## **Pro-Nets Technology Corporation**

FCC ID: RXZ-WP61R2

Picture 1

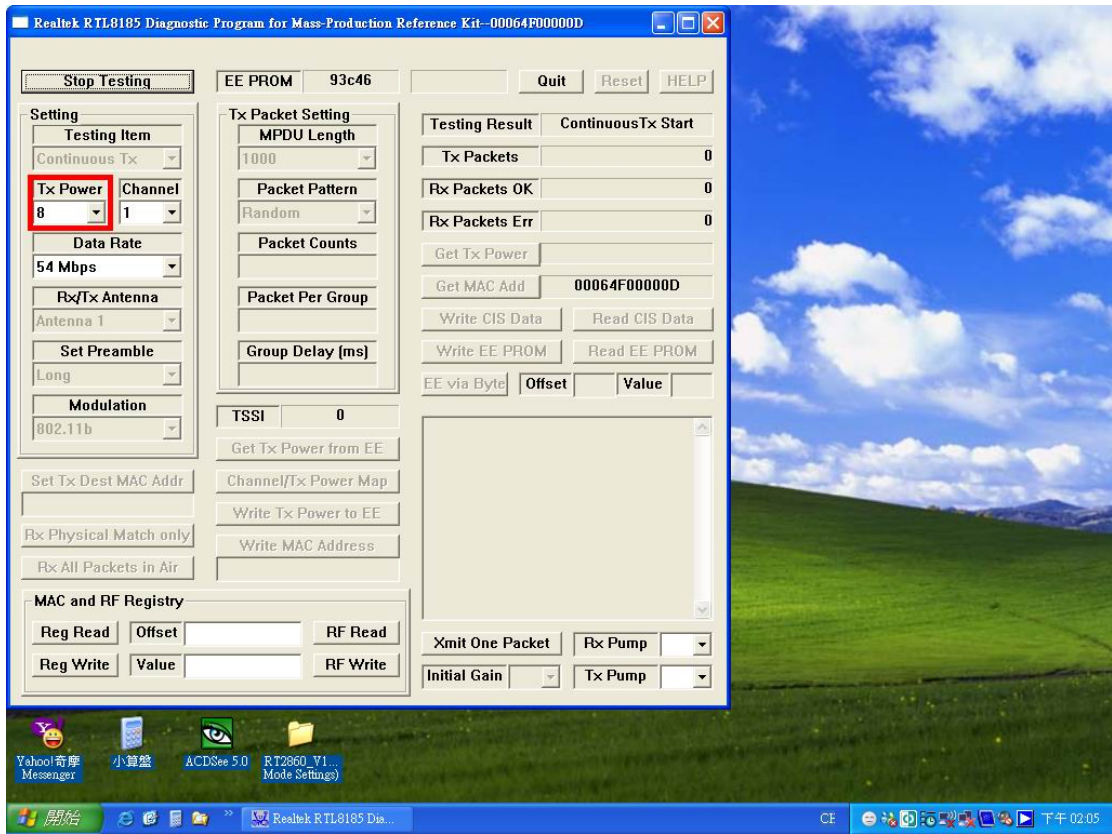
The reason we would like to update the test report on FCC website due to the omission of improper parameter (TX Power "8") was set for the prior testing and this resulted the lower conducted RF power with 802.11g mode. Please check the Picture 1 attached below for details.

Therefore, to get the rated RF power by the manufacturer the proper parameter must be set as "14", and this is used for the re-test data we need to correct and re-submitted to FCC.
